# SERVICE BULLETIN

M-888

## 1340cc GENERAL SERVICE INFORMATION

### Diaphragm Clutch

Figure 1. Adjusting Clutch Free Play

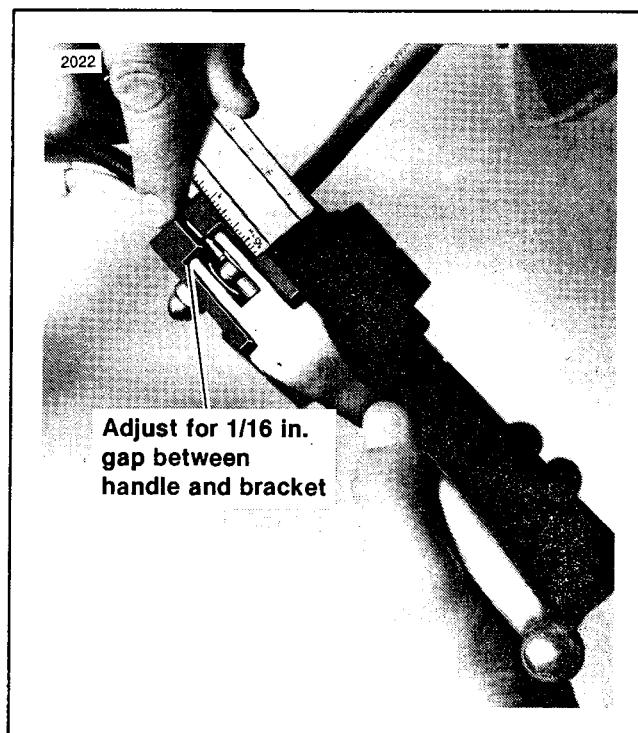
1. Follow the adjustment procedure given in Service Bulletin M-878; but, back-out adjusting screw (item 1, Figure 4 of Service Bulletin M-878) 3/4 turn instead of 1/8 - 1/4 turn specified in Service Bulletin M-878.

2. Reattach clutch cable to release arm and adjust clutch cable so 1/16 in. gap exists between clutch hand lever and bracket as shown in Figure 1 below.

1. Remove clutch cable from the release arm.
2. Loosen locknut (item 2, Figure 4 of Service Bulletin M-878) and turn adjusting screw (item 1, Figure 4 of Service Bulletin M-878) to position the release arm 13/16 in. from the tower on transmission cover. See Figure 5 in Service Bulletin M-878.
3. The above dimension must be checked with light finger pressure on the release arm to remove free play in the push rods.
4. Reattach clutch cable to release arm and adjust clutch cable to dimension shown in Figure 1. Refer to Figure 6 in Service Bulletin M-878.

Figure 2. Gasket Location

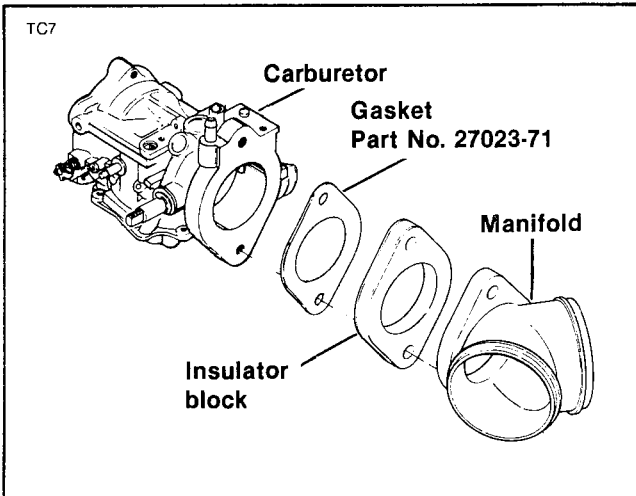
A gasket (Sportster Part No. 27023-71) has been added between the carburetor and the insulator block on all 1340cc engines assembled in February, 1984 and the remainder of the 1984 model year. See Figure 2.

On earlier 1340's, if an air leak is found or suspected between the carburetor and insulator block, install the gasket.

Figure 3. Misaligned Engine Mount

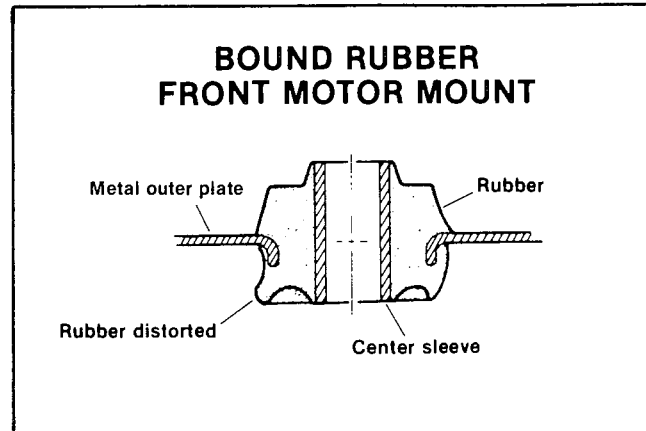
necessary because the mount functions as a damping spring. The smallest amount of preload can cause abnormal vibrations. If the mount is preloaded, the rubber will bulge, in one direction away from the outer metal plate. See Figure 3.

Figure 4. Aligning Mount Sideways

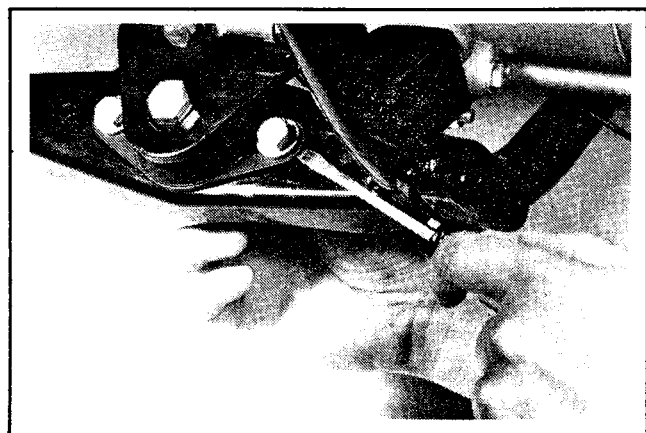
1. Remove the two voltage regulator bracket bolts.
2. Move the voltage regulator and bracket out of the way. Be careful not to damage wires connected to the voltage regulator.
3. With the engine weight on the mount, check that the two mount-to-frame bolts are loose. (These bolts should have been loosened in Step 9 of the VEHICLE ALIGNMENT procedure.)
4. See Figure 4. Push the mount outer plate from side to side until the rubber bulge feels even with the outer plate at the bottom side of the mount (equal bulge). Retighten the two mount bolts to 20 ft-lbs torque.

**Figure 5. Aligning Mount Front-to-Rear**

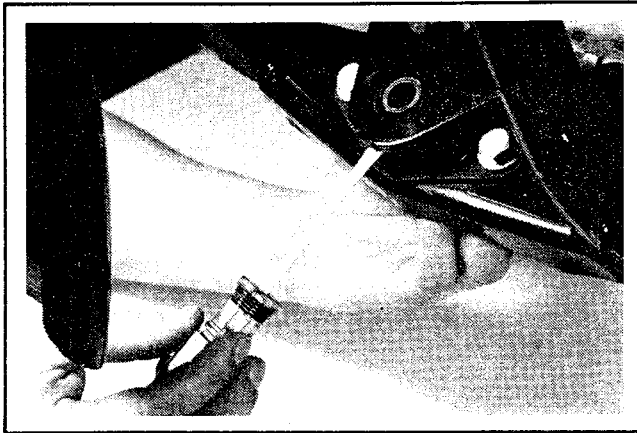
5. See Figure 5. Remove the long center bolt. Again leaving the engine weight on the mount, push the top of the center sleeve fore or aft to center the rubber bulge with the outer plate fore and aft at the bottom (equal bulge).

**Figure 6. Engine Mount Aligned**

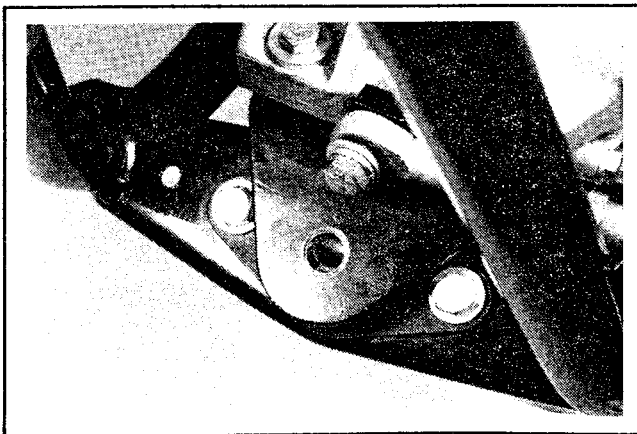
6. See Figure 6. With the mount now centered, the 1/2 in. hole in the mount plate may not align with the mount center sleeve. A smaller diameter thru-bolt may be necessary.

Do not install a smaller 3/8 in. diameter bolt without checking to determine if the 7/16 in. bolt will fit. The following tabulation lists part numbers for both 3/8 and 7/16 in. bolts, washers and nuts and the torque requirements.

7. Tighten the center thru-bolt to the applicable torque given in the previous tabulation.
8. Reinstall the voltage regulator and bracket.

**Figure 7. Recalibrating V.O.E.S.**

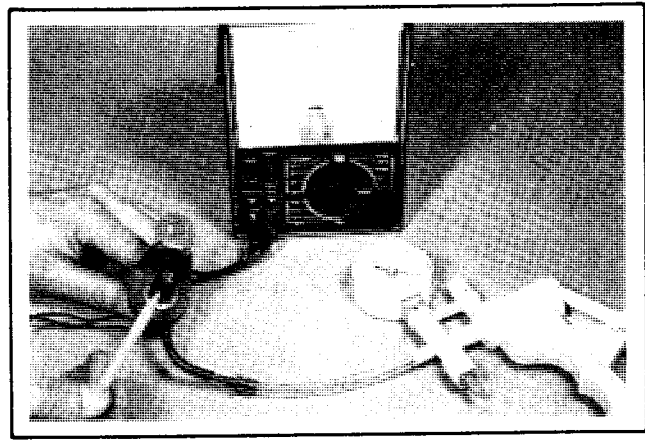
If engine hesitation occurs at 2500 rpm and lower rpm, recalibrate or replace the V.O.E.S. as follows.

1. Remove vacuum hose and check the hose nipple. If the hose nipple has a red paint dab, this identifies the switch as Part No. 26555-84 and recalibration is not required. (You may wish to check that V.O.E.S. is actuating at the correct vacuum.)
2. If hose nipple is unmarked, remove the V.O.E.S. and scrape out the silicone sealer at the top of the switch.
3. See Figure 7. Connect an ohmmeter to the switch leads and attach VACUUM PUMP, Part No. HD-23738 to vacuum hose nipple.
4. Reset the adjusting screw so the switch closes at 5 in. Hg.

5. Reseal the adjusting screw hole with silicone sealant.
